Addendum No. 2

Project Name:	35' Long x 102" Wide Heavy Duty Low Floor Diesel Powered Buses and Option Equipment	Project No.:	RFP: 16-17-31
Prepared By:	Denisha Harris	Date:	April 12, 2017

CITY OF GREENVILLE, NORTH CAROLINA REQUEST FOR APPROVED EQUALS OR CLARIFICATIONS

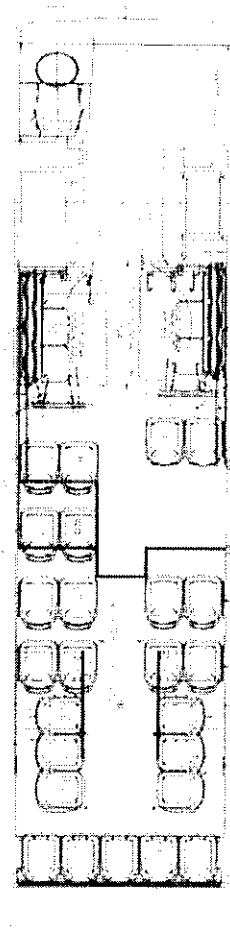
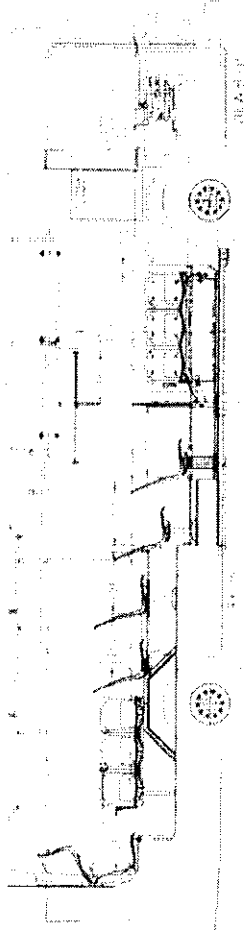
Request #	11		
Proposer:	GILLIG LLC		
RFP Section:	OVERALL DIMENSIONS		
Page:	24		
Customer Specification Requirement:			
Length Over Bumpers: 441.5			
Question, Clarification, or Approved Equal:			
GILLIG requests approval to provide an over the bumper bus length of 442.0".			
This is the standard length (over the bumpers) of a 35' GILLIG Low Floor bus.			
Customer Action:	<input checked="" type="checkbox"/>	Approved	<input type="checkbox"/> Denied
	<input type="checkbox"/>	See Addendum	<input type="checkbox"/> See Response Below
Customer Response:

LOW FLOOR

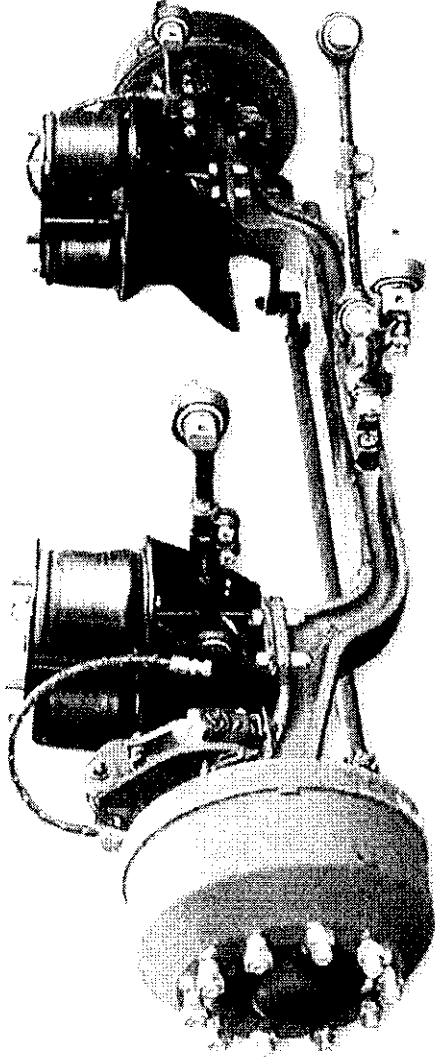
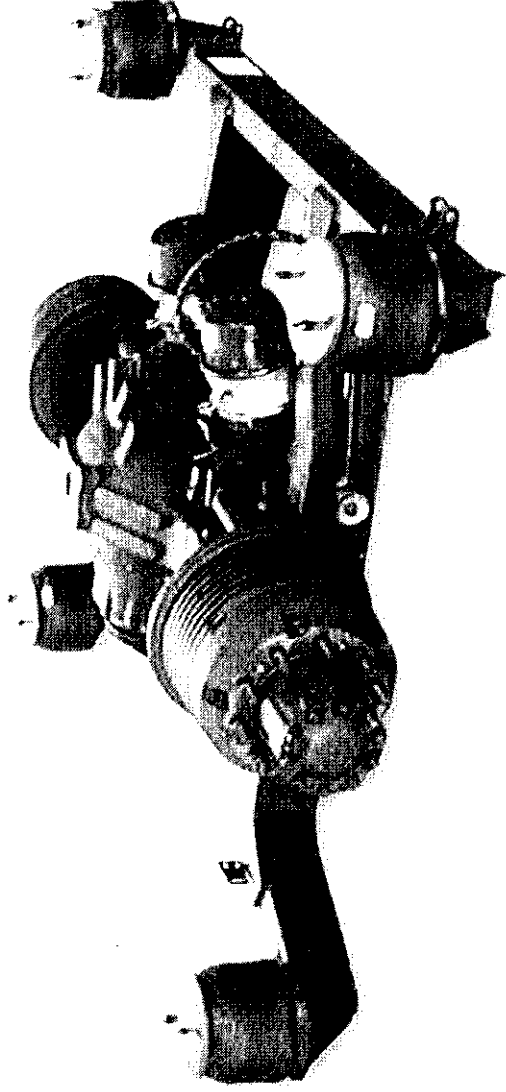
Question, Clarification, or Approved Equal:		
<p>GILLIG wishes to advise the Agency that neither the front or rear suspension on the Low Floor coach incorporates a "sway bar" in their design.</p> <p>GILLIG requests approval to provide our standard front and rear suspensions utilizing torque rods, track bars and radius rods to prevent the coach from swaying when turning or moving in and out of traffic.</p> <p>Please see attached.</p> <div style="text-align: center;">  Adobe Acrobat Document </div>		
Customer Action:	<input checked="" type="checkbox"/> Approved	<input type="checkbox"/> Denied
	<input type="checkbox"/> See Addendum	<input type="checkbox"/> See Response Below
Customer Response:

Towing Instructions

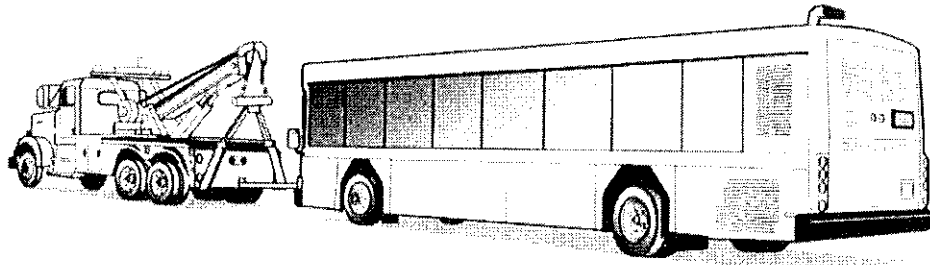
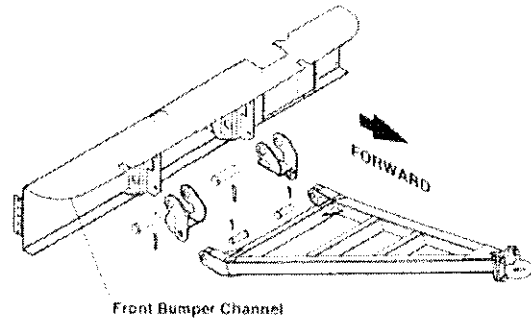
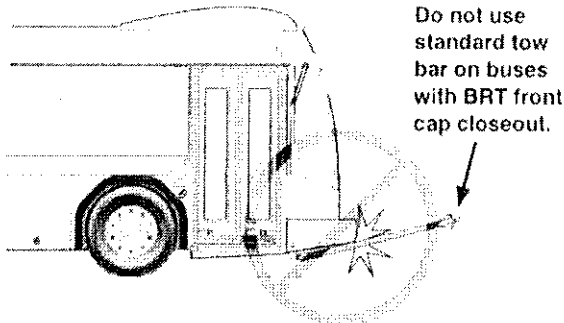
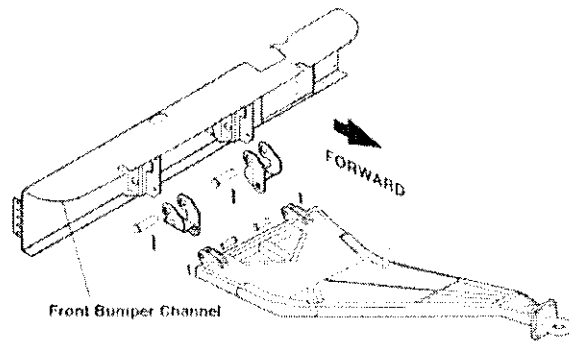
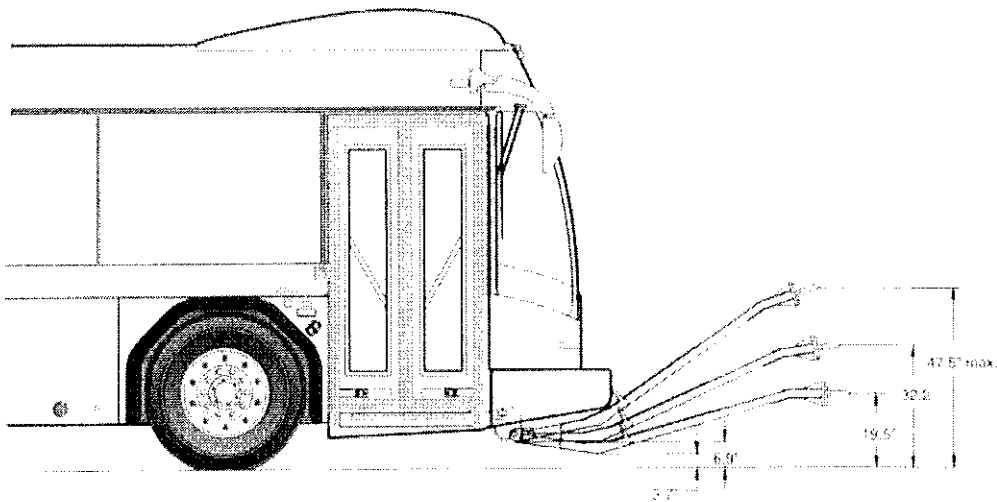
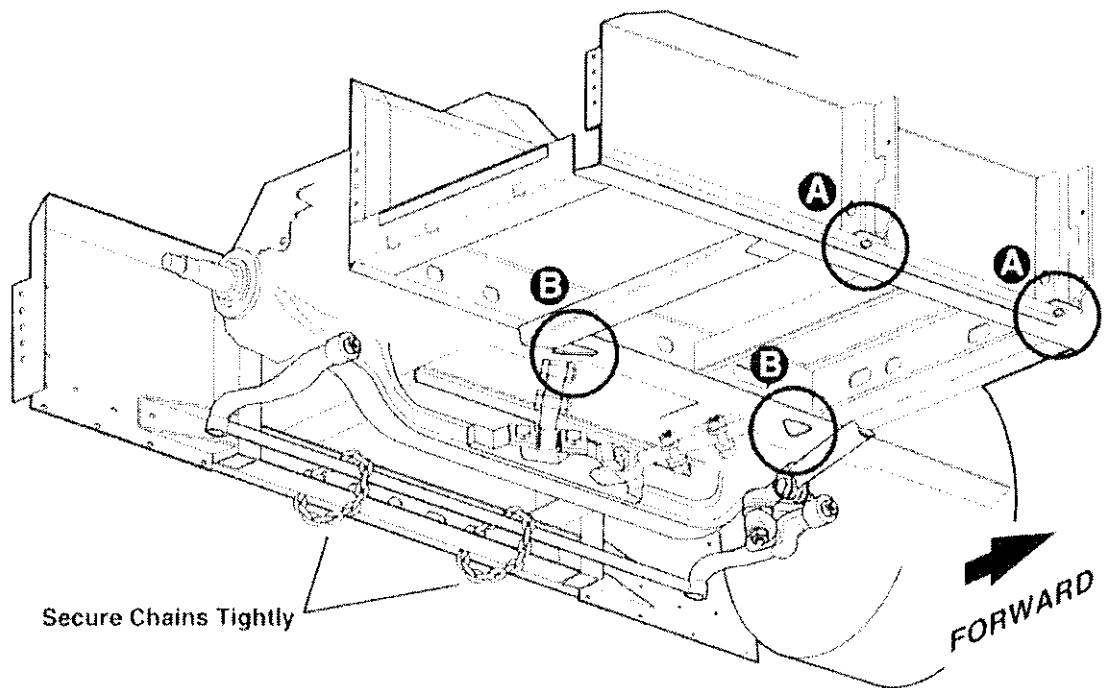
Question, Clarification, or Approved Equal:			
<p>GILLIG Low Floor buses incorporate towing provisions below the front bumper. Towing provisions consist of two eyes attached to the front frame cross member, with rear tow eyes incorporated in the rear most frame cross member.</p> <p>GILLIG requests concurrence.</p> <p>Please see attached.</p> <div style="text-align: center;">  Adobe Acrobat Document </div>			
Customer Action:	<input checked="" type="checkbox"/>	Approved	<input type="checkbox"/> Denied
	<input type="checkbox"/>	See Addendum	<input type="checkbox"/> See Response Below
Customer Response:

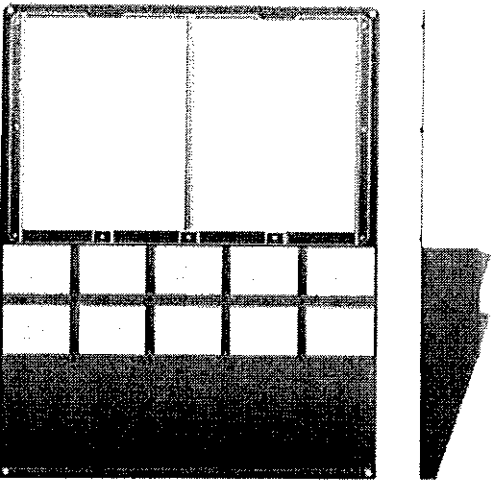
Request #	26		
Proposer:	GILLIG LLC		
RFP Section:	HVAC SYSTEMS		
Page:	35		
Customer Specification Requirement:			
<p>One (1) 24 volt auxiliary fans shall be mounted on the left hand corner and center of bottom of destination sign compartment.</p>			
Question, Clarification, or Approved Equal:			
<p>GILLIG requests approval to provide one (1) auxiliary dash fan, mounted on the right hand center of the dash.</p> <p>This configuration is consistent with the City's last GILLIG bus build.</p>			
Customer Action:	<input checked="" type="checkbox"/>	Approved	<input type="checkbox"/> Denied
	<input type="checkbox"/>	See Addendum	<input type="checkbox"/> See Response Below
Customer Response:

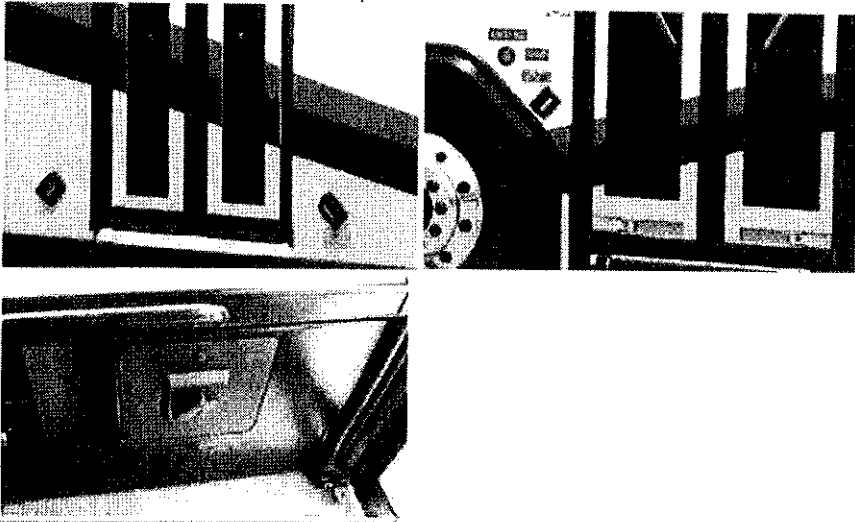
Request #	34			
Proposer:	GILLIG LLC			
RFP Section:	LIGHTING			
Page:	42			
Customer Specification Requirement:				
Headlights shall be wired to operate on reduced voltage in the run position				
Question, Clarification, or Approved Equal:				
GILLIG respectfully wishes to clarify that the LED headlamps on GILLIG Low Floor buses can't operate with low voltage. The headlamps can be operated in both day and night run positions, but the voltage applied to the lamps will not differ.				
Customer Action:	<input type="checkbox"/>	Approved	<input type="checkbox"/>	Denied
	<input type="checkbox"/>	See Addendum	<input checked="" type="checkbox"/>	See Response Below
Customer Response:		OKAY

GREENVILLE, N.C.

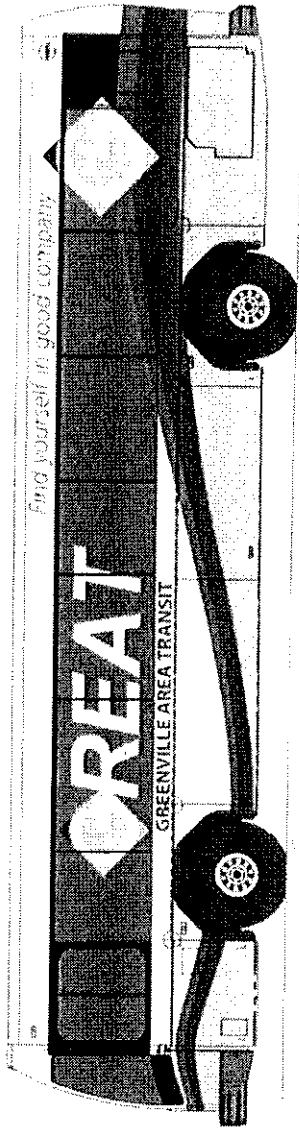
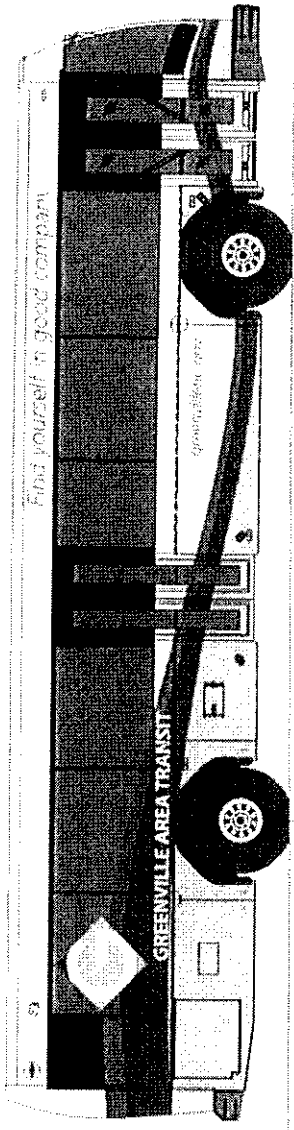
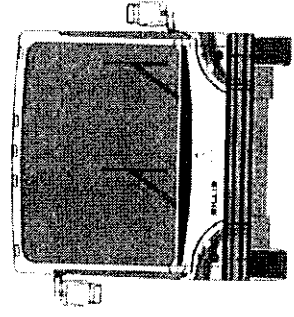
Question, Clarification, or Approved Equal:			
<p>The specifications does not include a sample of the paint scheme, graphics layout or a complete description of the exterior paint and graphics requirements. GILLIG is providing a paint/graphics layout that depicts a paint scheme and graphics layout for the City's approval.</p> <p>Please see attached.</p> <div style="text-align: center;">  Adobe Acrobat Document </div>			
Customer Action:	<input checked="" type="checkbox"/>	Approved	<input type="checkbox"/> Denied
	<input type="checkbox"/>	See Addendum	<input type="checkbox"/> See Response Below
Customer Response:
